SUBJECT: ISSUANCE OF AMENDMENT (TAC NOS. 82020 AND M84842) - TSCR 208/220

THREE MILE ISLAND NUCLEAR STATION, UNIT NO. 1

Amendment No. 168
License No. DPR-50

SAFETY EVALUATION BY THE OFFICE OF NUCLEAR REACTOR REGULATION
RELATED TO AMENDMENT NO. 168 TO FACILITY OPERATING LICENSE NO. DPR-50

Figure 3.5-2M

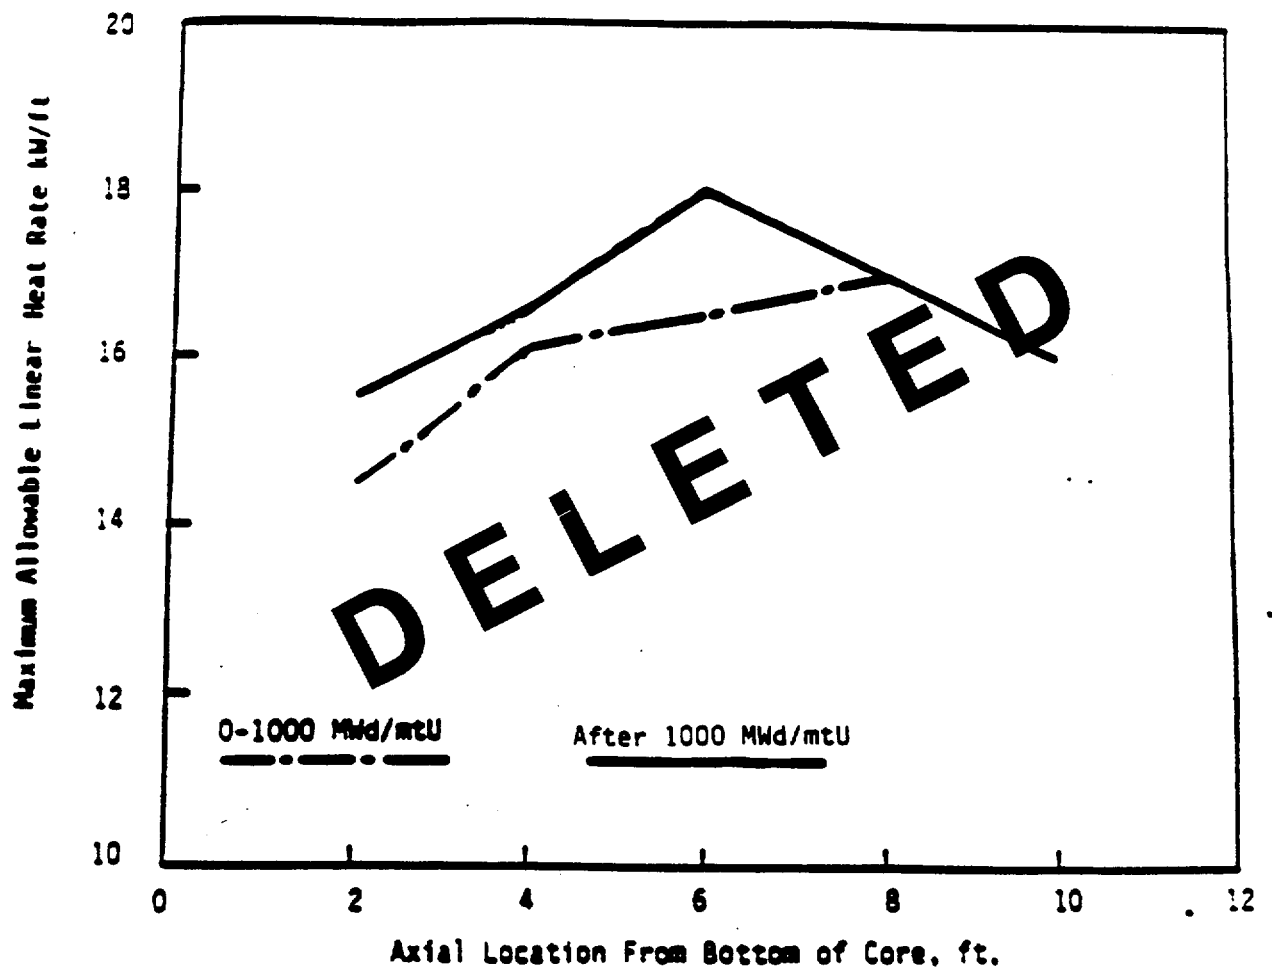
FIGURE DELETED AND INCORPORATED
 INTO THE CORE OPERATING LIMITS REPORT.

By letter dated August 9, 1991 and October 29, 1992, the GPU Nuclear Corporation (the licensee) submitted two requests for changes to the Three Mile Island Nuclear Station, Unit No. 1 (TMI-1) Technical Specifications (TS). The requested changes would revise the Technical Specifications Bases addressing the minimum borated water storage volumes with respect to the loss of coolant accident (LOCA) linear heat rate (LHR) allowable limits. Figure 3.5-2M, "LOCA Limited Maximum Allowable Linear Heat Rate," is revised to reflect the Babcock & Wilcox (B&W) re-evaluations of generic linear heat rate limits. The second requested change would remove Figure 3.5-2M from the TS and incorporate it into the TMI-1 Core Operating Limits Report (COLR).

By letter dated August 9, 1991, the licensee requested a change that would revise TMI-1 TS to reflect the B&W re-evaluation of the generic LOCA linear heat rate (LHR) allowable limits and to administratively update the Bases discussion associated with the minimum borated water storage volumes to ensure adequate shutdown margin. To assure preservation of 10 CFR 50.46 acceptance criteria over entire core life, the licensee developed new LOCA LHR limits using NRC approved B&W emergency core cooling system (ECCS) evaluation model and fuel performance computer codes (TS section 6.9.5.2 new references 9 through 12). From the analysis, LOCA LHR are required to be reduced at the 6 foot core evaluation from 16.5 to 16.1 Kw/ft at the beginning of core life (0 to 1000 MWD/MTU*) and from 18.0 to 16.1 Kw/ft for above 1000 MWD/MTU. To assure that internal fuel rod pressure does not exceed reactor coolant system (RCS) pressure, the LHR limits are reduced at all core levels as a function of maximum rod average fuel burnup from 36,375 to 60,000 MWD/MTU. Re-evaluation of the peak clad temperatures at various fuel elevations using NRC approved analytical methods determined that peak centerline temperature (PCT) values meet the acceptance criteria using the new LHR limits. These re-evaluations for the revised generic allowable LOCA LHR for B&W 177A lowered-loop plants confirm the preservation of the acceptance criteria. These changes are reflected in the revised Figure 3.5-2M.

Application of B&W Topical Report BAW-1016P-A "TACO-3 Fuel Pin Thermal Analysis Computer Code" causes a new restriction on the end-of-life LOCA LHR limits. Accordingly, in order to maintain fuel rod internal pressure below RCS pressure for higher burnups, the allowable end-of-life LOCA LHR limits for all fuel assembly elevations are reduced based on the burnup of the limiting fuel rods. Figure 3.5-2M incorporates a diagonally decreasing limit as a function of maximum rod average burnup from 36,375 to 60,000 MWD/MTU.

By letter dated October 29, 1992, the licensee requested a change that would remove TMI-1 Figure 3.5-2M from the TS and incorporate it into the COLR. The licensee's proposed changes to the TS are in accordance with the guidance provided by Generic Letter 88-16, which allows the removal of cycle-specific parameter limits from TS. All changes in cycle-specific parameter limits are to be documented in the COLR before each reload cycle or remaining part of a reload cycle and submitted to the NRC prior to operation with the new parameter limits.

On the basis of the review of the above items, the NRC staff concludes that the licensee has provided an acceptable response to those items as addressed in the NRC guidance in Generic Letter 88-16. Because plant operation continues to be limited in accordance with the values of cycle-specific parameter limits that are established using NRC approved methodologies, the NRC staff concludes that this change is administrative in nature and there is no impact on plant safety as a consequence. Accordingly, the staff finds that the proposed changes are acceptable.
